Central Gardens EXTERIOR

Assembly	Exterior Access Route
Type	Exterior Accessible Route
ADA Standard	303

Barrier Detail

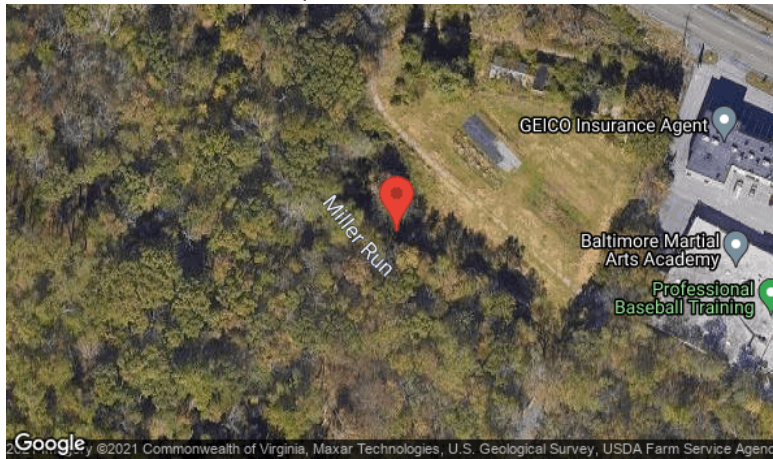
Assembly	Entrance to Building
Type	Building Entrance-Door
ADA Standard	305.2; 404.2
Barrier Detail	The maneuvering clearance at the accessible door is not level and clear.
Location Description	Pool House Entrance Door
Observed	May 28, 2021 by Lloyd.fojas@bureauveritas.com

For a front approach on the pull side the maneuvering clearance has a 9" vertical change at the face of the door.

Remove and replace the surface within the required maneuvering clearance area so that the surface is level and clear with maximum slope 1:48 (2.08%) in any direction. The required depth of the maneuvering clearance is 60" minimum. The required side clearance is 18" minimum on the latch side of the door. Maneuvering clearance shall extend the full width of the doorway and the required latch side clearance. Floor or ground space within the required maneuvering clearance shall be maximum 1:48 (2.08%) slope. Changes in level are not permitted.

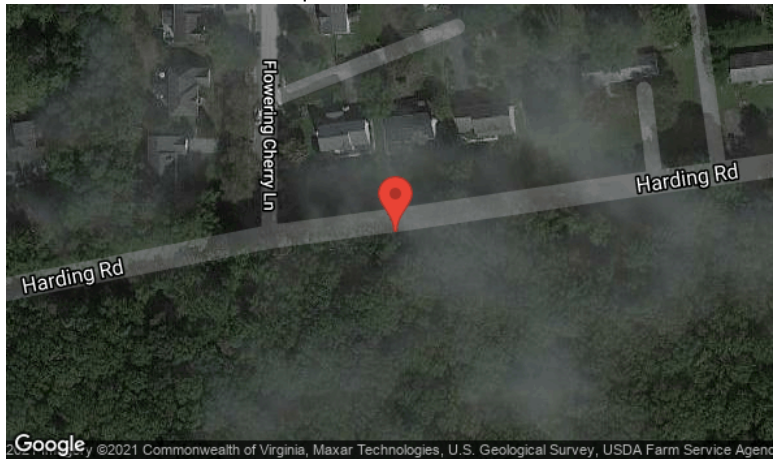
Assembly	Exterior Access Route
Type	Ramp
ADA Standard	405, 505
Barrier Detail	The ramp is required but not provided.
Location Description	To Building 6800 Entrance
Observed	May 28, 2021 by Lloyd.fojas@bureauveritas.com

There are two (2) 6-1/2" vertical changes on the accessible route to the building entrance. A ramp with a rise of 13" and a bottom landing is needed for entrance to the building.

Provide a compliant ramp or reduce the walking surface to maximum 1:20 (5%) running slope. The cost estimate for this barrier removal is based on providing a ramp, rather than grading the running slope to maximum 1:20 (5%). Ramp runs shall have a running slope not steeper than 1:12, and a cross slope not steeper than 1:48. [EXCEPTION: In existing sites built pre-1/26/92, buildings, and facilities, ramps shall be permitted to have running slopes steeper than 1:12 where such slopes are necessary due to space limitations. Where slopes are steeper than 1:10 but not steeper than 1:8, the rise shall be 3" maximum. Where slopes are steeper than 1:12 but not steeper than 1:10, the rise shall be 6" maximum.] The clear width of a ramp run and, where handrails are provided, the clear width between handrails shall be 36" minimum. The clear width of a ramp run and, where handrails are provided, the clear width between handrails shall be 36" minimum. [EXCEPTION: Within employee work areas, the required clear width of ramps that are a part of common use circulation paths shall be permitted to be decreased by work area equipment provided that the decrease is essential to the function of the work being performed.] Ramp runs shall have maximum 30" rise. Ramp landings shall be located at the top and bottom of ramp runs, and at turns of ramp direction. Landings shall be 1:48 maximum slope in any direction. Landings shall be minimum 60" length, and as wide as the ramp run, except ramp landings at turns which shall be minimum 60" x 60" minimum. All ramp runs with a rise of 6" or greater shall have handrails on each side of the ramp. Handrails shall be compliant. The top of the handrail gripping surface shall be 34" minimum to 38" maximum vertically above the ramp surface. Provide edge protection on the sides of each ramp run which rises more than 6" and on ramp landings. Compliant edge protection shall be provided on each side of ramp runs and at each side of ramp landings. Compliant edge protection is EITHER a curb or barrier that prevents the passage of a 4" diameter sphere where the sphere is within 4" of the ramp surface OR an extension of the ramp surface 12" minimum beyond the inner face of the rail. [EXCEPTIONS: 1. Edge protection shall not be required on ramps that are not required to have handrails and have sides. 2. Edge protection shall not be required on the sides of ramp landings serving an adjoining ramp run or stairway. 3. Edge protection shall not be required on the sides of ramp landings having a vertical drop-off of 1/2" maximum within 10" horizontally of the minimum required landing area.] Ramps and their approaches shall be designed so that water will not accumulate on walking surfaces.

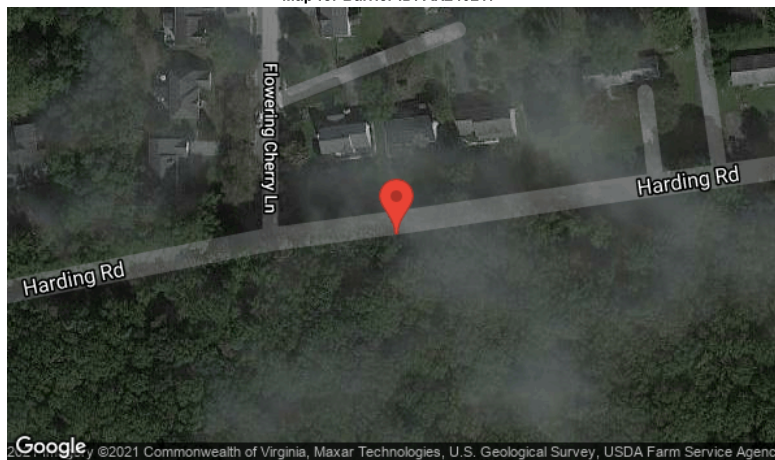
Assembly	Exterior Access Route
Type	Ramp
ADA Standard	405.8 and 505
Barrier Detail	The ramp run has a rise greater than 6"; however, handrails are not provided.
Location Description	To Building 6800 Entrance
Observed	May 28, 2021 by Lloyd.fojas@bureauveritas.com

Provide compliant handrails or provide ramp runs with maximum 6" rise. Handrails are required on ramp runs which rise more than 6". Replace with continuous handrails at a consistent height above the ramp on both sides of the ramp. Inside handrails on switchback or dogleg stairs and ramps shall be continuous between runs. Top of gripping surfaces of handrails shall be 34" minimum and 38" maximum vertically above ramp surfaces. Handrails shall be at a consistent height above ramp surfaces. Clearance between handrail gripping surfaces and adjacent surfaces shall be 1-1/2" minimum. Handrail gripping surfaces shall be continuous along their length and shall not be obstructed along their tops or sides. The bottoms of handrail gripping surfaces shall not be obstructed for more than 20% of their length. Where provided, horizontal projections shall occur 1-1/2" minimum below the bottom of the handrail gripping surface. [EXCEPTIONS: 1. Where handrails are provided along walking surfaces with slopes not steeper than 1:20, the bottoms of handrail gripping surfaces shall be permitted to be obstructed along their entire length where they are integral to crash rails or bumper guards. 2. The distance between horizontal projections and the bottom of the gripping surface shall be permitted to be reduced by 1/8" for each 1/2" of additional handrail perimeter dimension that exceeds 4".] Handrail gripping surfaces with a circular cross section shall have an outside diameter of 1-1/4" minimum and 2" maximum. Handrail gripping surfaces with a non-circular cross section shall have a perimeter dimension of 4" minimum and 6-1/4" maximum, and a cross-section dimension of 2-1/4" maximum. Handrail gripping surfaces and any surfaces adjacent to them shall be free of sharp or abrasive elements and shall have rounded edges. Handrails shall not rotate within their fittings. Handrail gripping surfaces shall extend beyond and in the same direction of ramp runs. [EXCEPTIONS: 1. Extensions shall not be required for continuous handrails at the inside turn of switchback or dogleg ramps AND 3. In alterations, full extensions of handrails shall not be required where such extensions would be hazardous due to plan configuration.] Ramp handrails shall extend horizontally above the landing for 12" minimum beyond the top and bottom of ramp runs. Extensions shall return to a wall, guard, or the landing surface, or shall be continuous to the handrail of an adjacent ramp run.

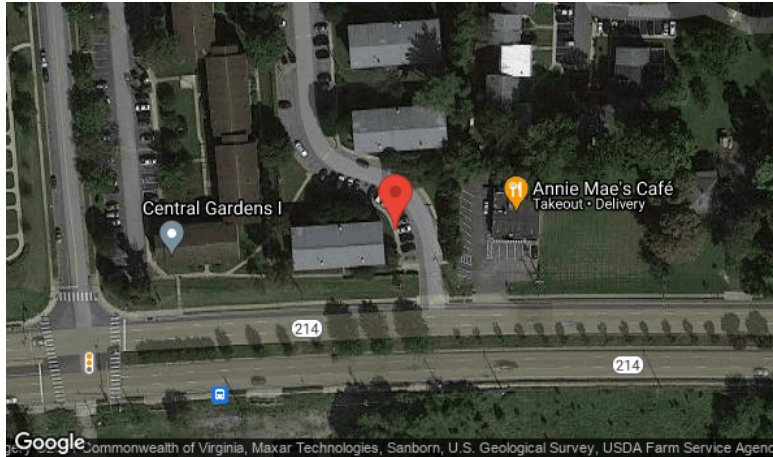
Assembly	Exterior Access Route
Type	Ramp
ADA Standard	405, 505
Barrier Detail	The ramp is required but not provided.
Location Description	To Building 6802
Observed	May 28, 2021 by Lloyd.fojas@bureauveritas.com

The accessible route to the door has a 8" and a 6" vertical change. A ramp with a rise of 14" and a bottom landing is needed.

Provide a compliant ramp or reduce the walking surface to maximum 1:20 (5%) running slope. The cost estimate for this barrier removal is based on providing a ramp, rather than grading the running slope to maximum 1:20 (5%). Ramp runs shall have a running slope not steeper than 1:12, and a cross slope not steeper than 1:48. [EXCEPTION: In existing sites built pre-1/26/92, buildings, and facilities, ramps shall be permitted to have running slopes steeper than 1:12 where such slopes are necessary due to space limitations. Where slopes are steeper than 1:10 but not steeper than 1:8, the rise shall be 3" maximum. Where slopes are steeper than 1:12 but not steeper than 1:10, the rise shall be 6" maximum.] The clear width of a ramp run and, where handrails are provided, the clear width between handrails shall be 36" minimum. The clear width of a ramp run and, where handrails are provided, the clear width between handrails shall be 36" minimum. [EXCEPTION: Within employee work areas, the required clear width of ramps that are a part of common use circulation paths shall be permitted to be decreased by work area equipment provided that the decrease is essential to the function of the work being performed.] Ramp runs shall have maximum 30" rise. Ramp landings shall be located at the top and bottom of ramp runs, and at turns of ramp direction. Landings shall be 1:48 maximum slope in any direction. Landings shall be minimum 60" length, and as wide as the ramp run, except ramp landings at turns which shall be minimum 60" x 60" minimum. All ramp runs with a rise of 6" or greater shall have handrails on each side of the ramp. Handrails shall be compliant. The top of the handrail gripping surface shall be 34" minimum to 38" maximum vertically above the ramp surface. Provide edge protection on the sides of each ramp run which rises more than 6" and on ramp landings. Compliant edge protection shall be provided on each side of ramp runs and at each side of ramp landings. Compliant edge protection is EITHER a curb or barrier that prevents the passage of a 4" diameter sphere where the sphere is within 4" of the ramp surface OR an extension of the ramp surface 12" minimum beyond the inner face of the rail. [EXCEPTIONS: 1. Edge protection shall not be required on ramps that are not required to have handrails and have sides. 2. Edge protection shall not be required on the sides of ramp landings serving an adjoining ramp run or stairway. 3. Edge protection shall not be required on the sides of ramp landings having a vertical drop-off of 1/2" maximum within 10" horizontally of the minimum required landing area.] Ramps and their approaches shall be designed so that water will not accumulate on walking surfaces.

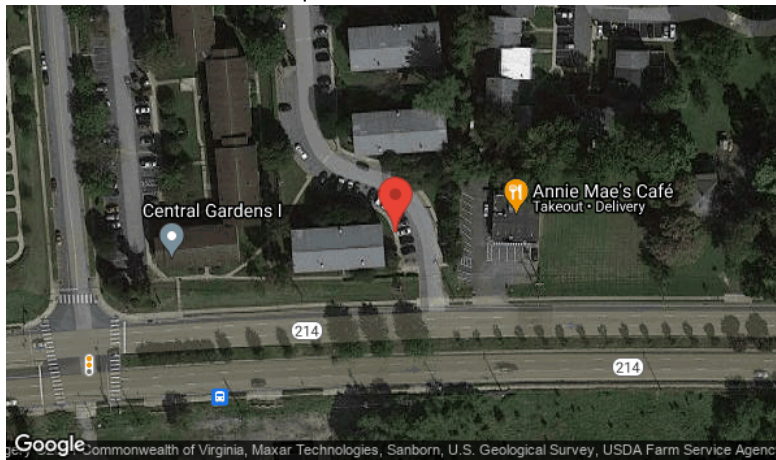
Assembly	Exterior Access Route
Type	Ramp
ADA Standard	405.8 and 505
Barrier Detail	The ramp run has a rise greater than 6"; however, handrails are not provided.
Location Description	To Building 6802
Observed	May 28, 2021 by Lloyd.fojas@bureauveritas.com

The accessible route to the door has a 8" and a 6" vertical change. A ramp with a rise of 14" and a bottom landing is needed. The new ramp will need handrails.

Provide compliant handrails or provide ramp runs with maximum 6" rise. Handrails are required on ramp runs which rise more than 6". Replace with continuous handrails at a consistent height above the ramp on both sides of the ramp. Inside handrails on switchback or dogleg stairs and ramps shall be continuous between runs. Top of gripping surfaces of handrails shall be 34" minimum and 38" maximum vertically above ramp surfaces. Handrails shall be at a consistent height above ramp surfaces. Clearance between handrail gripping surfaces and adjacent surfaces shall be 1-1/2" minimum. Handrail gripping surfaces shall be continuous along their length and shall not be obstructed along their tops or sides. The bottoms of handrail gripping surfaces shall not be obstructed for more than 20% of their length. Where provided, horizontal projections shall occur 1-1/2" minimum below the bottom of the handrail gripping surface. [EXCEPTIONS: 1. Where handrails are provided along walking surfaces with slopes not steeper than 1:20, the bottoms of handrail gripping surfaces shall be permitted to be obstructed along their entire length where they are integral to crash rails or bumper guards. 2. The distance between horizontal projections and the bottom of the gripping surface shall be permitted to be reduced by 1/8" for each 1/2" of additional handrail perimeter dimension that exceeds 4".] Handrail gripping surfaces with a circular cross section shall have an outside diameter of 1-1/4" minimum and 2" maximum. Handrail gripping surfaces with a non-circular cross section shall have a perimeter dimension of 4" minimum and 6-1/4" maximum, and a cross-section dimension of 2-1/4" maximum. Handrail gripping surfaces and any surfaces adjacent to them shall be free of sharp or abrasive elements and shall have rounded edges. Handrails shall not rotate within their fittings. Handrail gripping surfaces shall extend beyond and in the same direction of ramp runs. [EXCEPTIONS: 1. Extensions shall not be required for continuous handrails at the inside turn of switchback or dogleg ramps AND 3. In alterations, full extensions of handrails shall not be required where such extensions would be hazardous due to plan configuration.] Ramp handrails shall extend horizontally above the landing for 12" minimum beyond the top and bottom of ramp runs. Extensions shall return to a wall, guard, or the landing surface, or shall be continuous to the handrail of an adjacent ramp run.

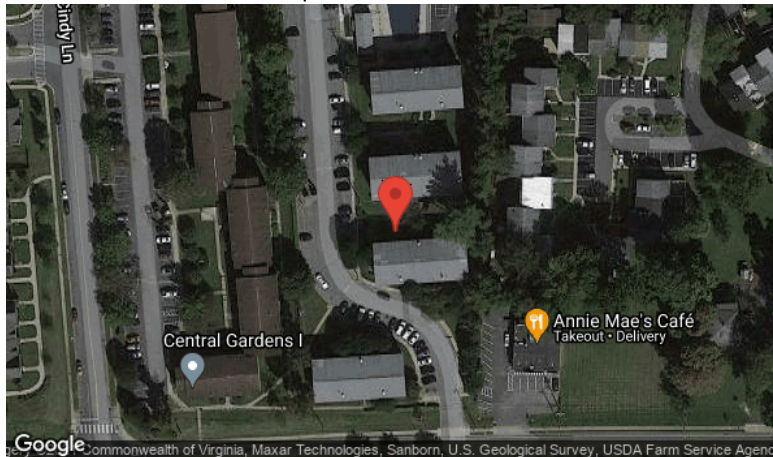
Assembly	Exterior Access Route
Type	Ramp
ADA Standard	405, 505
Barrier Detail	The ramp is required but not provided.
Location Description	To Building 6804 Entrance
Observed	May 28, 2021 by Lloyd.fojas@bureauveritas.com

The accessible route has a set of stairs with 5 risers and a 7" vertical change at the door. A ramp with a rise of 42", a bottom landing and 1 intermediate landing is needed.

Provide a compliant ramp or reduce the walking surface to maximum 1:20 (5%) running slope. The cost estimate for this barrier removal is based on providing a ramp, rather than grading the running slope to maximum 1:20 (5%). Ramp runs shall have a running slope not steeper than 1:12, and a cross slope not steeper than 1:48. [EXCEPTION: In existing sites built pre-1/26/92, buildings, and facilities, ramps shall be permitted to have running slopes steeper than 1:12 where such slopes are necessary due to space limitations. Where slopes are steeper than 1:10 but not steeper than 1:8, the rise shall be 3" maximum. Where slopes are steeper than 1:12 but not steeper than 1:10, the rise shall be 6" maximum.] The clear width of a ramp run and, where handrails are provided, the clear width between handrails shall be 36" minimum. The clear width of a ramp run and, where handrails are provided, the clear width between handrails shall be 36" minimum. [EXCEPTION: Within employee work areas, the required clear width of ramps that are a part of common use circulation paths shall be permitted to be decreased by work area equipment provided that the decrease is essential to the function of the work being performed.] Ramp runs shall have maximum 30" rise. Ramp landings shall be located at the top and bottom of ramp runs, and at turns of ramp direction. Landings shall be 1:48 maximum slope in any direction. Landings shall be minimum 60" length, and as wide as the ramp run, except ramp landings at turns which shall be minimum 60" x 60" minimum. All ramp runs with a rise of 6" or greater shall have handrails on each side of the ramp. Handrails shall be compliant. The top of the handrail gripping surface shall be 34" minimum to 38" maximum vertically above the ramp surface. Provide edge protection on the sides of each ramp run which rises more than 6" and on ramp landings. Compliant edge protection shall be provided on each side of ramp runs and at each side of ramp landings. Compliant edge protection is EITHER a curb or barrier that prevents the passage of a 4" diameter sphere where the sphere is within 4" of the ramp surface OR an extension of the ramp surface 12" minimum beyond the inner face of the rail. [EXCEPTIONS: 1. Edge protection shall not be required on ramps that are not required to have handrails and have sides. 2. Edge protection shall not be required on the sides of ramp landings serving an adjoining ramp run or stairway. 3. Edge protection shall not be required on the sides of ramp landings having a vertical drop-off of 1/2" maximum within 10" horizontally of the minimum required landing area.] Ramps and their approaches shall be designed so that water will not accumulate on walking surfaces.

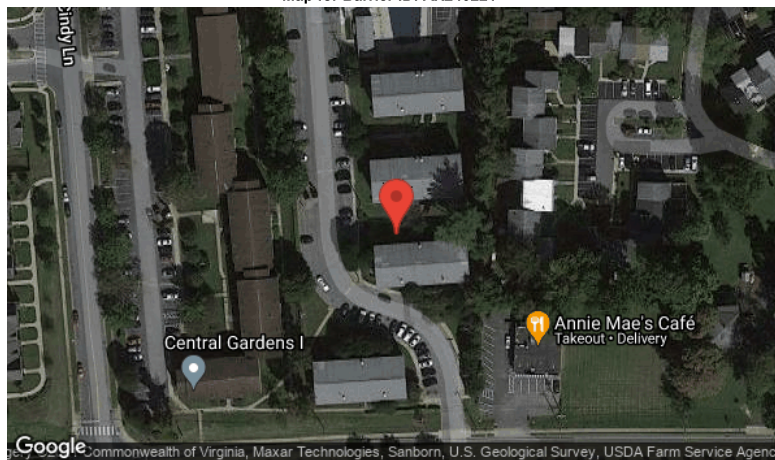
Assembly	Exterior Access Route
Type	Ramp
ADA Standard	405.8 and 505
Barrier Detail	The ramp run has a rise greater than 6"; however, handrails are not provided.
Location Description	To Building 6804 Entrance
Observed	May 28, 2021 by Lloyd.fojas@bureauveritas.com

The accessible route has a set of stairs with 5 risers and a 7" vertical change at the door. A ramp with a rise of 42", a bottom landing and 1 intermediate landing is needed. The new ramp will need handrails.

Provide compliant handrails or provide ramp runs with maximum 6" rise. Handrails are required on ramp runs which rise more than 6". Replace with continuous handrails at a consistent height above the ramp on both sides of the ramp. Inside handrails on switchback or dogleg stairs and ramps shall be continuous between runs. Top of gripping surfaces of handrails shall be 34" minimum and 38" maximum vertically above ramp surfaces. Handrails shall be at a consistent height above ramp surfaces. Clearance between handrail gripping surfaces and adjacent surfaces shall be 1-1/2" minimum. Handrail gripping surfaces shall be continuous along their length and shall not be obstructed along their tops or sides. The bottoms of handrail gripping surfaces shall not be obstructed for more than 20% of their length. Where provided, horizontal projections shall occur 1-1/2" minimum below the bottom of the handrail gripping surface. [EXCEPTIONS: 1. Where handrails are provided along walking surfaces with slopes not steeper than 1:20, the bottoms of handrail gripping surfaces shall be permitted to be obstructed along their entire length where they are integral to crash rails or bumper guards. 2. The distance between horizontal projections and the bottom of the gripping surface shall be permitted to be reduced by 1/8" for each 1/2" of additional handrail perimeter dimension that exceeds 4".] Handrail gripping surfaces with a circular cross section shall have an outside diameter of 1-1/4" minimum and 2" maximum. Handrail gripping surfaces with a non-circular cross section shall have a perimeter dimension of 4" minimum and 6-1/4" maximum, and a cross-section dimension of 2-1/4" maximum. Handrail gripping surfaces and any surfaces adjacent to them shall be free of sharp or abrasive elements and shall have rounded edges. Handrails shall not rotate within their fittings. Handrail gripping surfaces shall extend beyond and in the same direction of ramp runs. [EXCEPTIONS: 1. Extensions shall not be required for continuous handrails at the inside turn of switchback or dogleg ramps AND 3. In alterations, full extensions of handrails shall not be required where such extensions would be hazardous due to plan configuration.] Ramp handrails shall extend horizontally above the landing for 12" minimum beyond the top and bottom of ramp runs. Extensions shall return to a wall, guard, or the landing surface, or shall be continuous to the handrail of an adjacent ramp run.

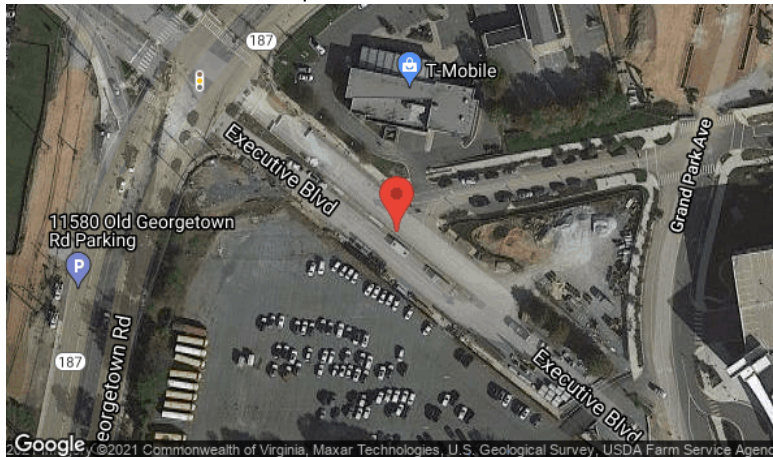
Assembly	Exterior Access Route
Type	Ramp
ADA Standard	405, 505
Barrier Detail	The ramp is required but not provided.
Location Description	To Building 6810 Entrance
Observed	May 28, 2021 by Lloyd.fojas@bureauveritas.com

The accessible route has a set of stairs with 5 risers and a 7-1/2" vertical change at the door. A ramp with a rise of 45", a bottom landing and 1 intermediate landing is needed.

Provide a compliant ramp or reduce the walking surface to maximum 1:20 (5%) running slope. The cost estimate for this barrier removal is based on providing a ramp, rather than grading the running slope to maximum 1:20 (5%). Ramp runs shall have a running slope not steeper than 1:12, and a cross slope not steeper than 1:48. [EXCEPTION: In existing sites built pre-1/26/92, buildings, and facilities, ramps shall be permitted to have running slopes steeper than 1:12 where such slopes are necessary due to space limitations. Where slopes are steeper than 1:10 but not steeper than 1:8, the rise shall be 3" maximum. Where slopes are steeper than 1:12 but not steeper than 1:10, the rise shall be 6" maximum.] The clear width of a ramp run and, where handrails are provided, the clear width between handrails shall be 36" minimum. The clear width of a ramp run and, where handrails are provided, the clear width between handrails shall be 36" minimum. [EXCEPTION: Within employee work areas, the required clear width of ramps that are a part of common use circulation paths shall be permitted to be decreased by work area equipment provided that the decrease is essential to the function of the work being performed.] Ramp runs shall have maximum 30" rise. Ramp landings shall be located at the top and bottom of ramp runs, and at turns of ramp direction. Landings shall be 1:48 maximum slope in any direction. Landings shall be minimum 60" length, and as wide as the ramp run, except ramp landings at turns which shall be minimum 60" x 60" minimum. All ramp runs with a rise of 6" or greater shall have handrails on each side of the ramp. Handrails shall be compliant. The top of the handrail gripping surface shall be 34" minimum to 38" maximum vertically above the ramp surface. Provide edge protection on the sides of each ramp run which rises more than 6" and on ramp landings. Compliant edge protection shall be provided on each side of ramp runs and at each side of ramp landings. Compliant edge protection is EITHER a curb or barrier that prevents the passage of a 4" diameter sphere where the sphere is within 4" of the ramp surface OR an extension of the ramp surface 12" minimum beyond the inner face of the rail. [EXCEPTIONS: 1. Edge protection shall not be required on ramps that are not required to have handrails and have sides. 2. Edge protection shall not be required on the sides of ramp landings serving an adjoining ramp run or stairway. 3. Edge protection shall not be required on the sides of ramp landings having a vertical drop-off of 1/2" maximum within 10" horizontally of the minimum required landing area.] Ramps and their approaches shall be designed so that water will not accumulate on walking surfaces.

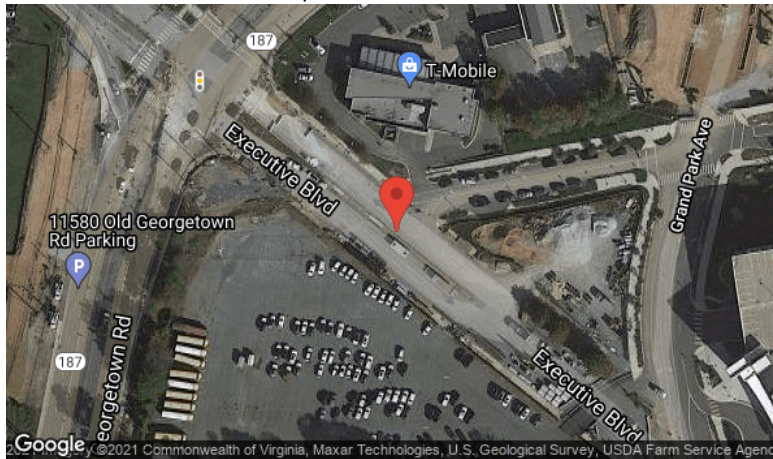
Assembly	Exterior Access Route
Type	Ramp
ADA Standard	405, 505
Barrier Detail	The ramp is required but not provided.
Location Description	To Building 6812 Entrance
Observed	May 28, 2021 by Lloyd.fojas@bureauveritas.com

The accessible route has a set of stairs with 5 risers and a 7-1/2" vertical change at the door. A ramp with a rise of 45", a bottom landing and 1 intermediate landing is needed.

Provide a compliant ramp or reduce the walking surface to maximum 1:20 (5%) running slope. The cost estimate for this barrier removal is based on providing a ramp, rather than grading the running slope to maximum 1:20 (5%). Ramp runs shall have a running slope not steeper than 1:12, and a cross slope not steeper than 1:48. [EXCEPTION: In existing sites built pre-1/26/92, buildings, and facilities, ramps shall be permitted to have running slopes steeper than 1:12 where such slopes are necessary due to space limitations. Where slopes are steeper than 1:10 but not steeper than 1:8, the rise shall be 3" maximum. Where slopes are steeper than 1:12 but not steeper than 1:10, the rise shall be 6" maximum.] The clear width of a ramp run and, where handrails are provided, the clear width between handrails shall be 36" minimum. The clear width of a ramp run and, where handrails are provided, the clear width between handrails shall be 36" minimum. [EXCEPTION: Within employee work areas, the required clear width of ramps that are a part of common use circulation paths shall be permitted to be decreased by work area equipment provided that the decrease is essential to the function of the work being performed.] Ramp runs shall have maximum 30" rise. Ramp landings shall be located at the top and bottom of ramp runs, and at turns of ramp direction. Landings shall be 1:48 maximum slope in any direction. Landings shall be minimum 60" length, and as wide as the ramp run, except ramp landings at turns which shall be minimum 60" x 60" minimum. All ramp runs with a rise of 6" or greater shall have handrails on each side of the ramp. Handrails shall be compliant. The top of the handrail gripping surface shall be 34" minimum to 38" maximum vertically above the ramp surface. Provide edge protection on the sides of each ramp run which rises more than 6" and on ramp landings. Compliant edge protection shall be provided on each side of ramp runs and at each side of ramp landings. Compliant edge protection is EITHER a curb or barrier that prevents the passage of a 4" diameter sphere where the sphere is within 4" of the ramp surface OR an extension of the ramp surface 12" minimum beyond the inner face of the rail. [EXCEPTIONS: 1. Edge protection shall not be required on ramps that are not required to have handrails and have sides. 2. Edge protection shall not be required on the sides of ramp landings serving an adjoining ramp run or stairway. 3. Edge protection shall not be required on the sides of ramp landings having a vertical drop-off of 1/2" maximum within 10" horizontally of the minimum required landing area.] Ramps and their approaches shall be designed so that water will not accumulate on walking surfaces.
